**ROYAL BOROUGH OF WINDSOR & MAIDENHEAD  
PLANNING COMMITTEE**

**WINDSOR URBAN DEVELOPMENT CONTROL PANEL**

| <b>Location:</b>                                                                                                                                                                                   | 130 St Andrews Crescent Windsor SL4 4EN                                                                                                                                                                            |
| <b>Proposal:</b>                                                                                                                                                                                   | Alterations to the roof to facilitate loft conversion with x3 side (north-west) facing dormers and x1 side (south-east) facing dormer and x1 rear Juliette balcony and alterations to fenestration (retrospective) |

FRONT(NORTH-EAST) ELEVATION

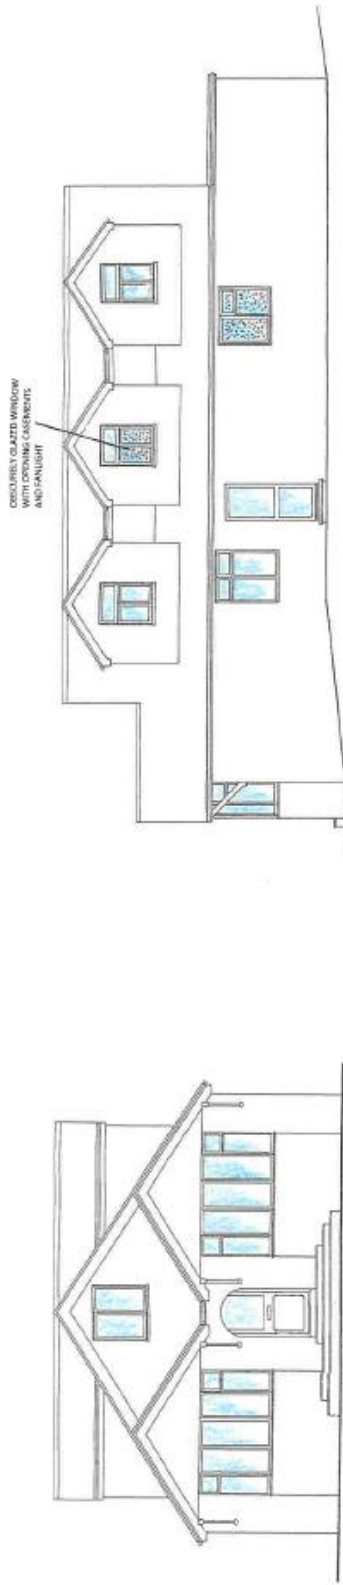
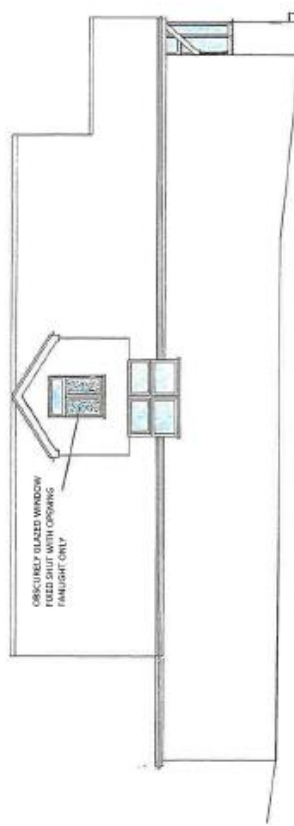
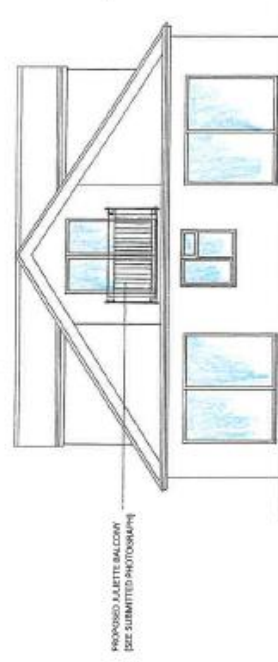
- 7.7 The current application demonstrates the proposed balcony would comprise railings fixed to the wall and extending across the width of the French doors serving bedroom 6 and would not provide any outdoor amenity area, despite the retention of the flat roof above the single storey element of the building. The presence of these railings are considered to ameliorate the impact of the proposed French doors, which would not result in any greater propensity for overlooking of neighbouring properties than a conventional window at first floor level. It is recommended, however, that a condition is attached to any permission that may be forthcoming restricting the use of the flat roof for any outdoor amenity purpose in order to overcome any potential issues of overlooking.

- 7.8 Despite the imposition of a condition on planning permission 16/00790/FULL requiring the two rearmost dormers in the northwest facing roofslope be fitted and permanently maintained with obscure glass and opening 1.7m above floor level, the glazing installed on site is clear and opening. The condition also required and the window within the dormer in the southeast facing roofslope to be fitted and permanently maintained with obscure glass and opening 1.7m above floor level, however, the glazing within the foremost dormer window in the northwest roofslope was not restricted by means condition. There are no material changes to the application site or the neighbouring properties which would overcome the need for such a condition to be carried over to this current application. Whilst it is acknowledged that the windows were fitted on the basis of guidance provided by the Building Inspector this does not alter the planning considerations for these windows and it is clear that the installation of clear-glazed opening windows has resulted in a poor relationship with the neighbouring properties and cannot be supported. However, paragraph 54 of the NPPF states that Local Planning Authorities should consider whether otherwise unacceptable development could be made acceptable through the use of conditions. Such conditions must be necessary, relevant to planning and to the development to be permitted, enforceable, precise and reasonable in all other respects. It is therefore considered that the glazing installed in the side windows could be managed via the means of a planning condition rather than proving fatal to the assessment of this application.

- 7.9 In considering the nature of the condition to be attached, it is clear that the existing windows result in an unacceptable degree of overlooking. Classes A, B and C of the Town and Country Planning (General Permitted Development) Order 2015 allow first floor windows in a side elevations provided they are obscure-glazed and non-opening unless the parts of the window which can be opened are more than 1.7 metres above the floor of the room in which the window is installed. In order to comply with the tests set out in paragraphs 55 and 56 of the NPPF it is therefore considered that a repeat of the condition attached to planning permission 16/00790/FULL, which would be in line with permitted development restrictions set out in Article 3, Schedule 2 and Part 1 of the GPDO, would be practicable and reasonable whilst adequately protecting the privacy of neighbouring properties. Condition 3 is recommended in relation to the windows.

- 3 Notwithstanding the design of the windows shown on the approved plans, the windows within the two rearmost dormers in the northwest facing roofslope and the window within the dormer in the south east facing roofslope of the extension shall be of a permanently fixed, non-opening design, with the exception of an opening toplight that is a minimum of 1.7m above the finished internal floor level, and fitted with obscure glass and the window shall not be altered without the prior written approval of the Local Planning Authority.  
Reason: To prevent overlooking and loss of privacy to neighbouring occupiers. Relevant Policies - Local Plan H14.

TITLE  
SWEEPED PATH ANALYSIS

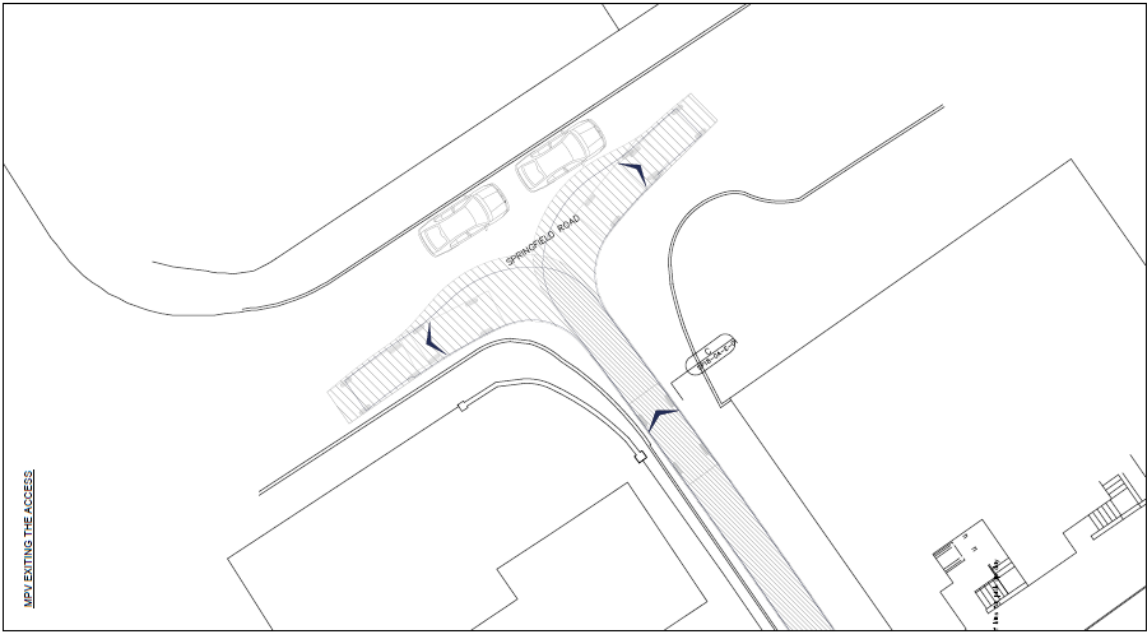
- 7.15 The application has been accompanied by a swept path analysis and the parking layout would indicate that vehicles would be able to turn on-site in order to allow vehicles to enter and exit in a forward gear. However there is inadequate space to allow for deliveries or removal vehicles without blocking parked vehicles or for delivery vehicles to turn.
